H2OAKS DESALINATION FACILITY WELL SITE DEVELOPMENT PROJECT

Job No.: 18-8607

ADDENDUM 4

May 15, 2020

DESIGN BY:	JP
DRAWN BY:	SG
CHECKED BY:	SM
APPROVED BY:	SM
JOB NO:	6542-0233
DATE:	2020-4-17
SHEET:	E-01

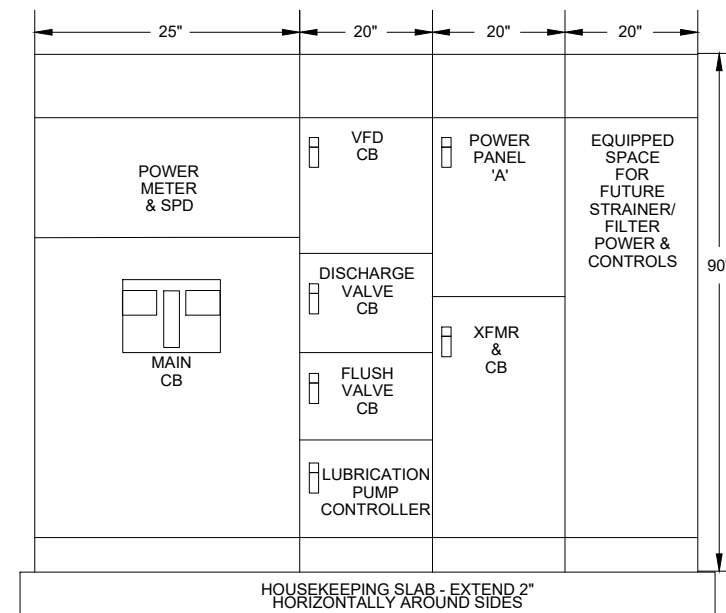
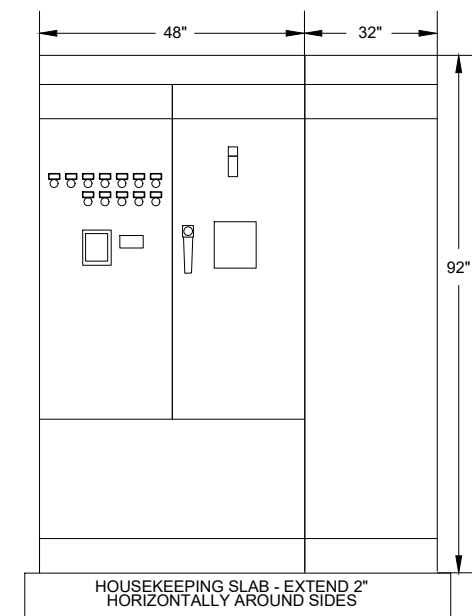
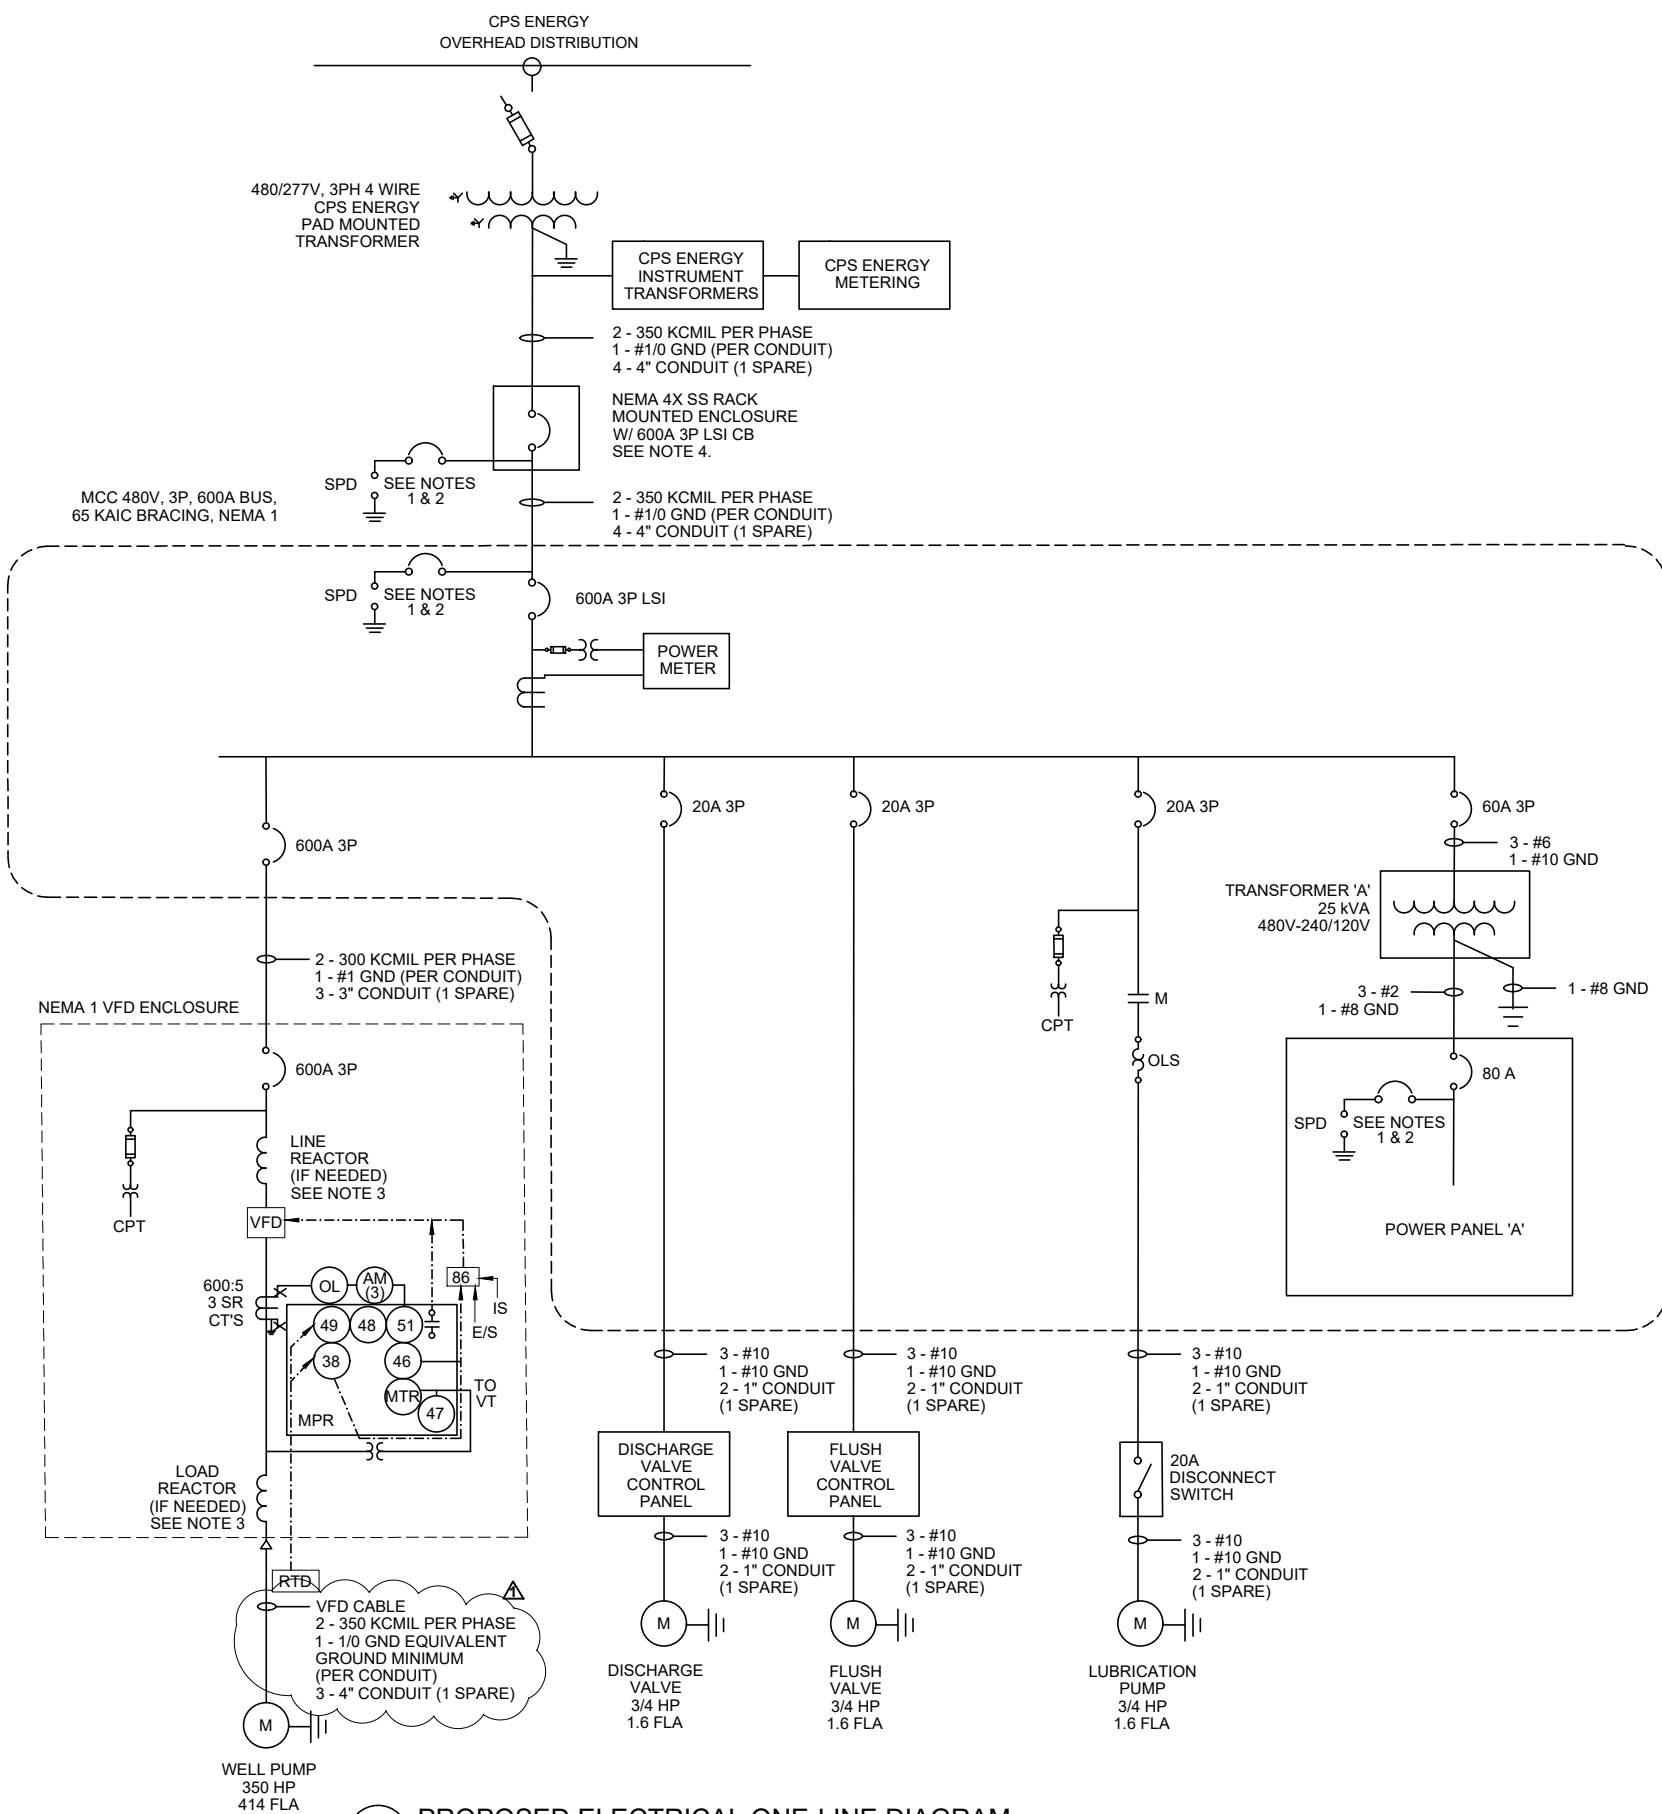
- 2. Specification Section 26 05 19 2.3 states VFD cable to be 3-conductor with 3 symmetrical ground cables, however, one-line diagram and ductbank schedules show these to be parallel 3-1/C 300 KCMIL with 1-1/C #1 ground. Please clarify which is to be used.**

9. There is a discrepancy between E-01 One-Line diagram for the Lubrication Pump circuit and both Ductbank Schedules E-12 & E-13. Please clarify which is to be used.

Response: Multiconductor cable per Section 26 05 19 2.3 shall be used. Refer to Changes to the Plans Items 2, 4, and 5 (sheets E-01, E-12, and E-13).
- 3. Sheet E-10 shows disconnect switch for Air Handler Unit #1 & #2 however, sheet E-04 the panel schedule does not show any breakers for them. Please advise.**

Response: Refer to Changes to the Plans items 2, 4, and 5 (sheets E-01, E-12, and E-13).

DESIGN BY:	JP
DRAWN BY:	SG
CHECKED BY:	SM
APPROVED BY:	SM
JOB NO:	6542-0233
DATE:	2020-4-17
SHEET:	E-10

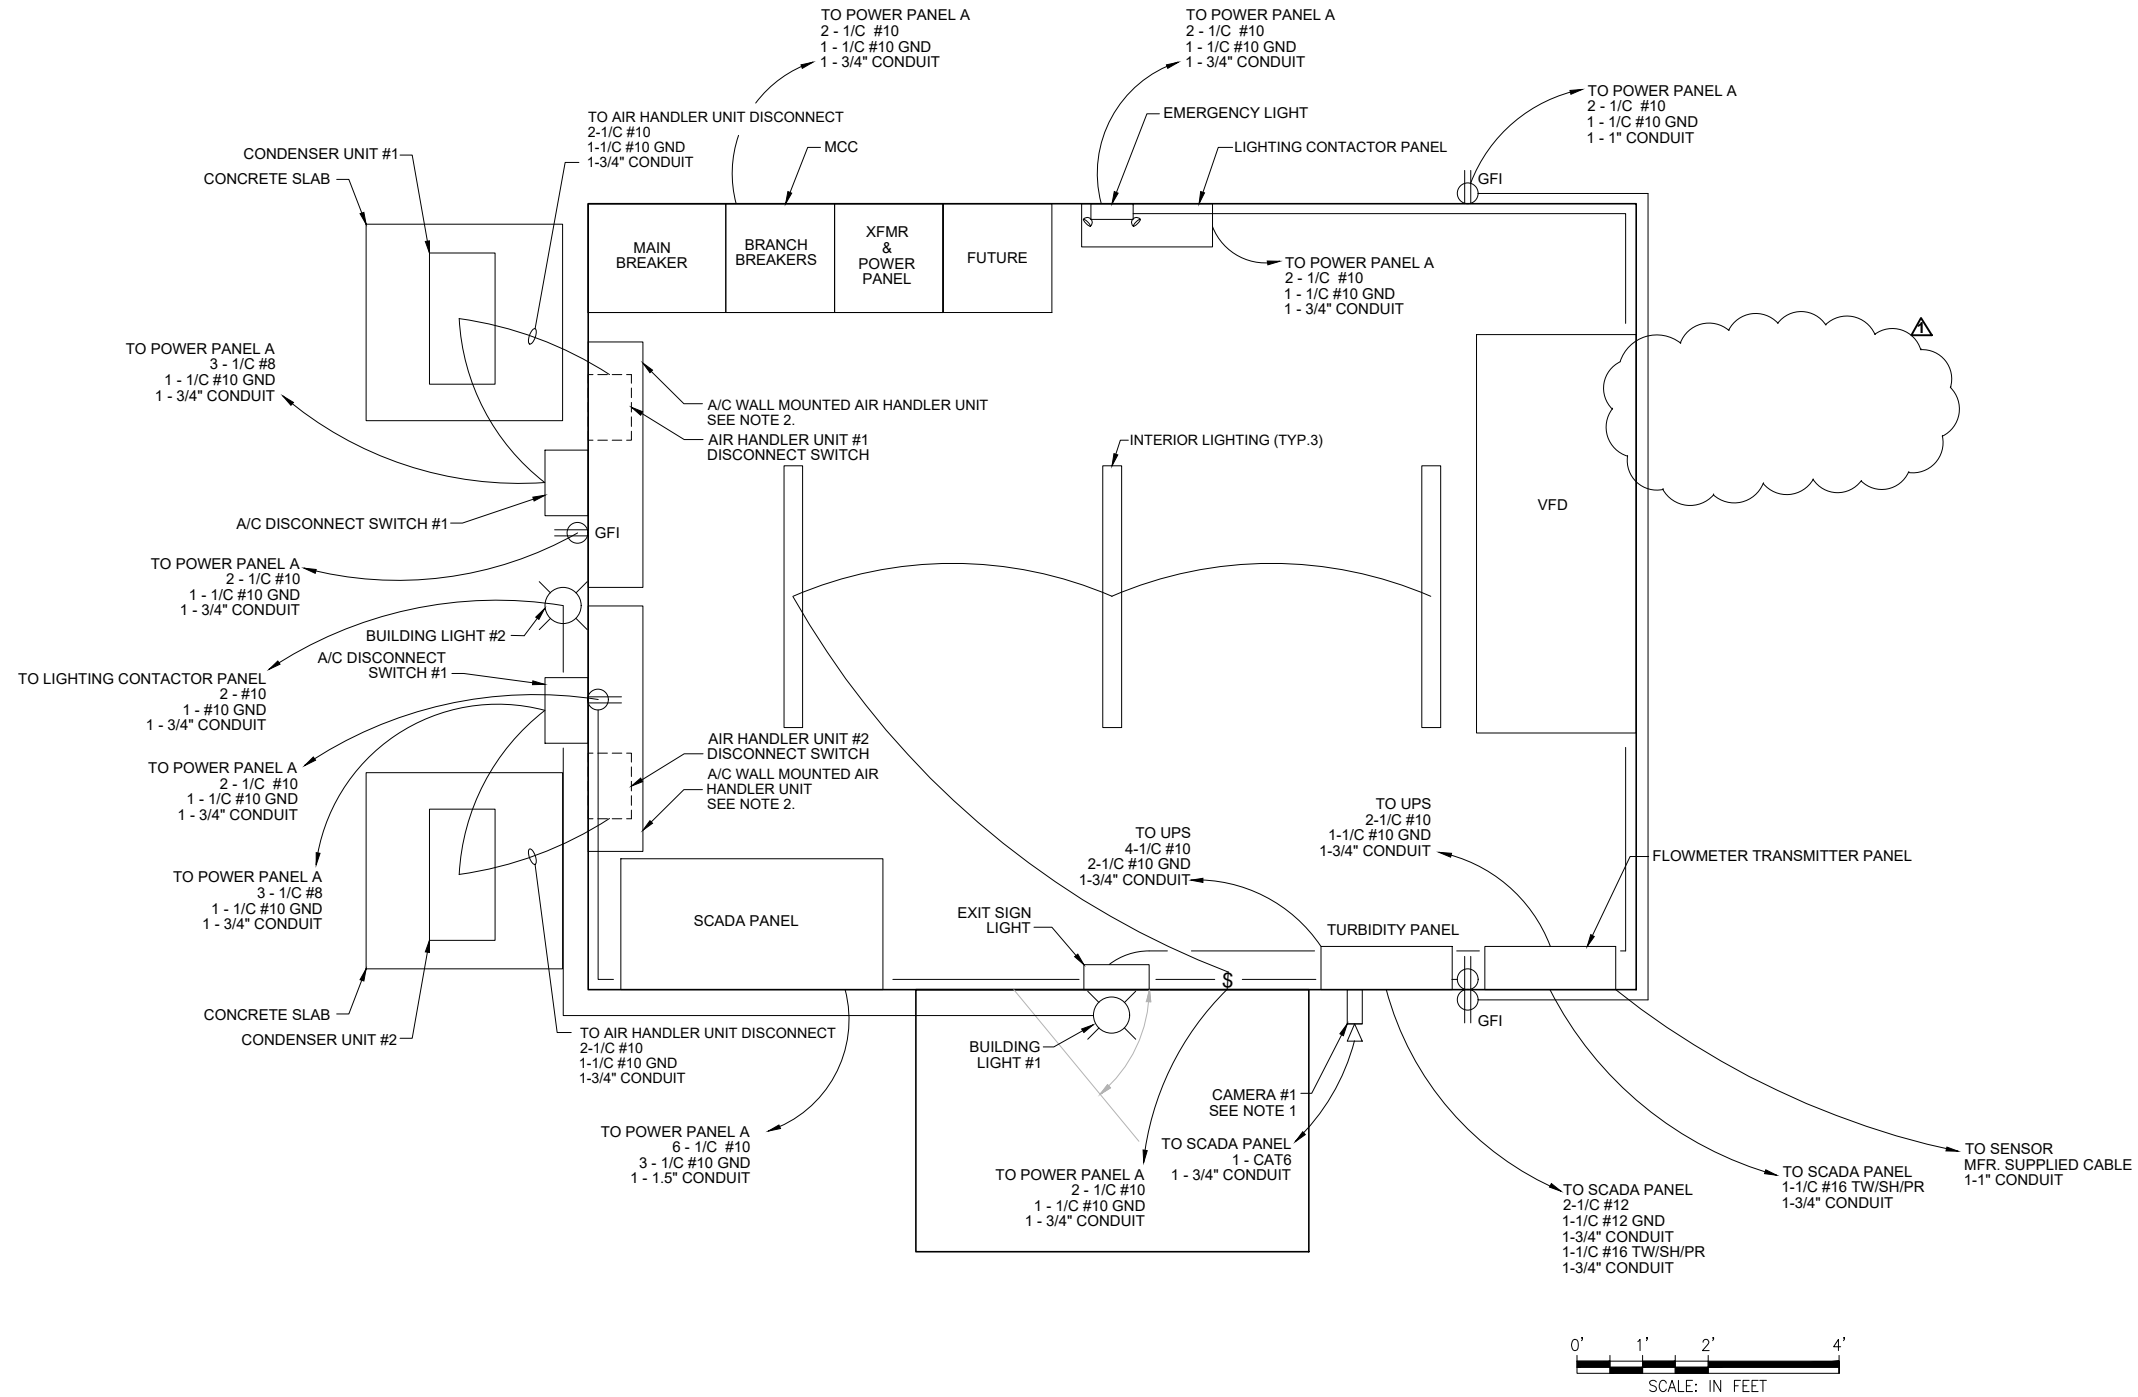
- 5. Please provide wiring requirements or connection diagram for SCADA to MCC & VFD's as they are not shown on the Electrical Building layout. Are we to assume wire & conduit sizes for the circuits shown on the SCADA interconnect Drawings I-03 thru I-05 for those not shown on the ductbank schedules? Please advise.**

Response: For this equipment power is supplied to the condenser which in turn powers the air handler unit. Both have a disconnect switch. Refer to Changes to the Plans Item 3 (sheet E-10).

Response: Wiring requirements have been added. Refer to Changes to the Plans Items 3, 4, 5, and 6 (sheets E-10, E-12, E-13, and I-04).
- 6. What are the circuit being routed to the Well Pump Instrument Cabinet at both sites? Both TW-1 & BDG-14 duct bank schedules show instruments at the well to be routed back to the Electrical building, unlike Controls circuits which are being routed to Well Pump Control Cabinets. Are the Instrument Cabinets at the well sites just a junction box for the Well Pump instrumentation back to the Electrical Building? Please clarify.**

JOB NO: 6542-0233
DATE: 2020-4-17
SHEET: E-13

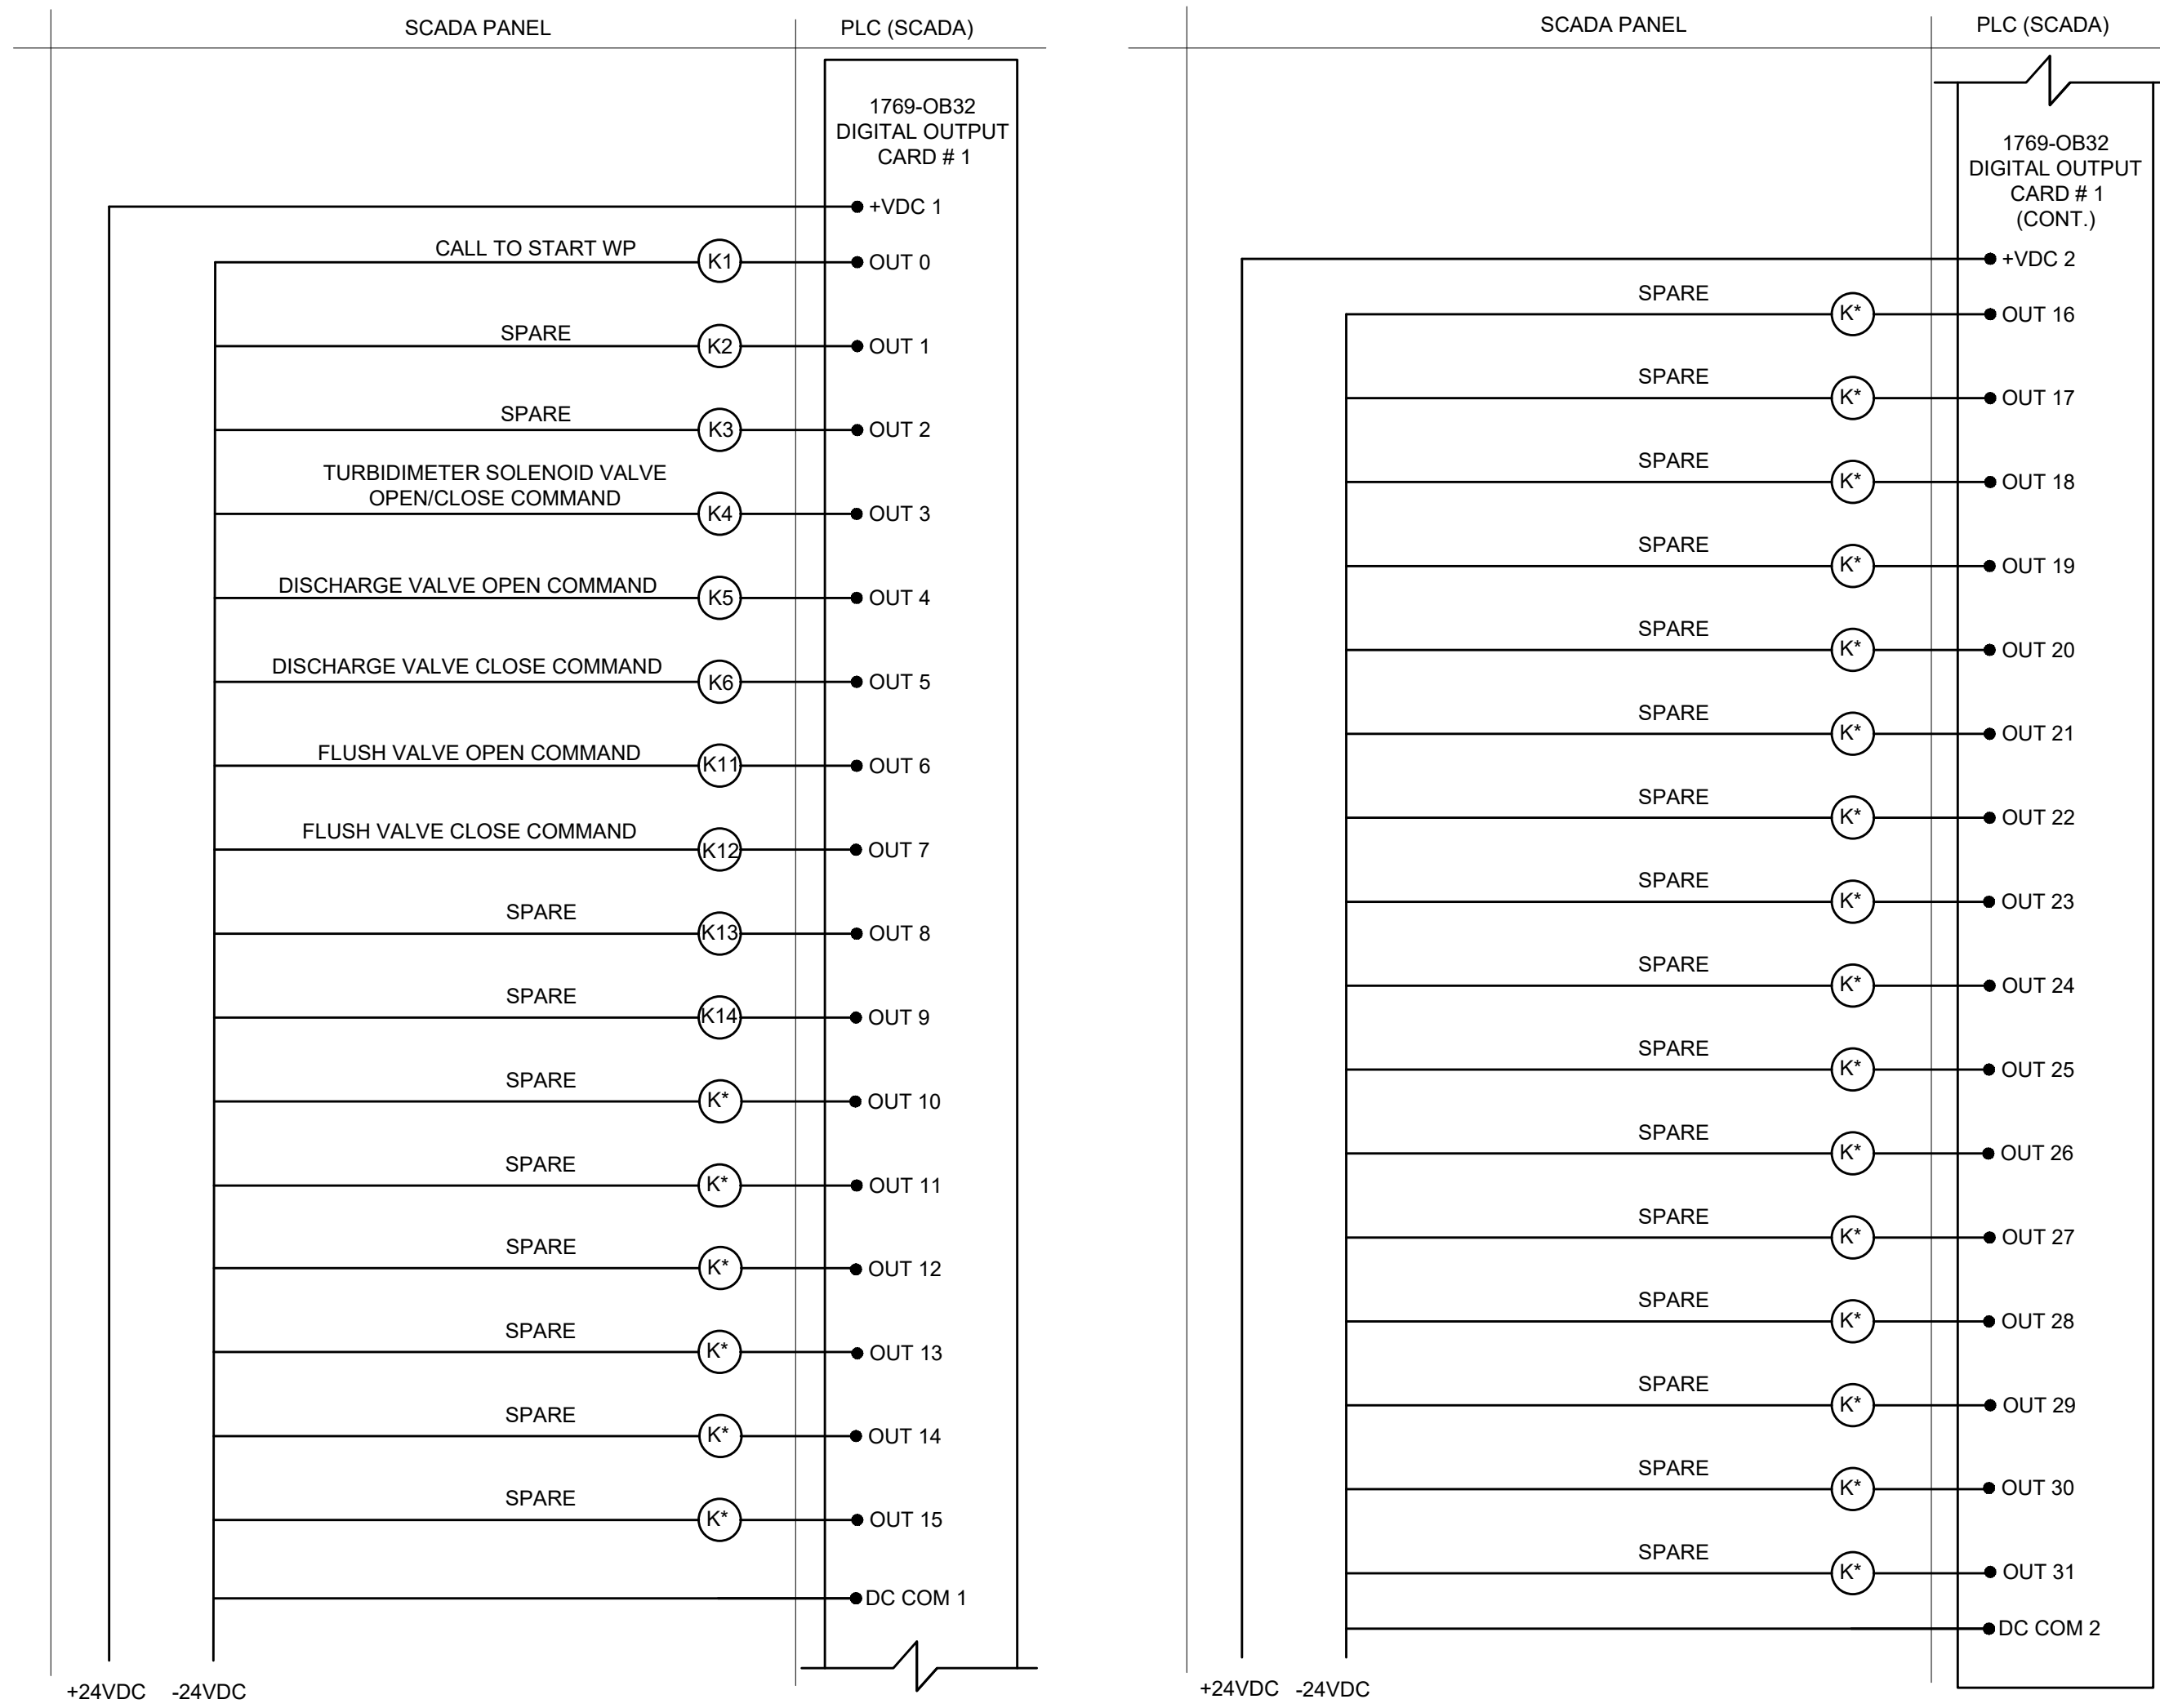
- 4. Well pump motor RTD circuits are not shown on DB schedules for both sites.**
Response: Well pump motor RTD circuits have been added. Refer to Changes to the Plans Items 4 and 5 (sheets E-12 and E-13).

10. There are inconsistencies in the ductbank schedules, for example, on TW-1 Conduit Schedule, Conduit # 31 is 2" containing 5#12 wires yet Conduit #34 is 1" for the same number of #12 wires, in addition, the schedule shows 1.5" Conduits for #40, #48, #41, & #49 with (10) #12 or (19) #12 wires. Please clarify whether 2" conduit for # 31 is an error. Similar situation occurs for BGD-14 ductbank schedule.

Response: Refer to Changes to the Plans Items 4 and 5 (sheets E-12 and E-13).
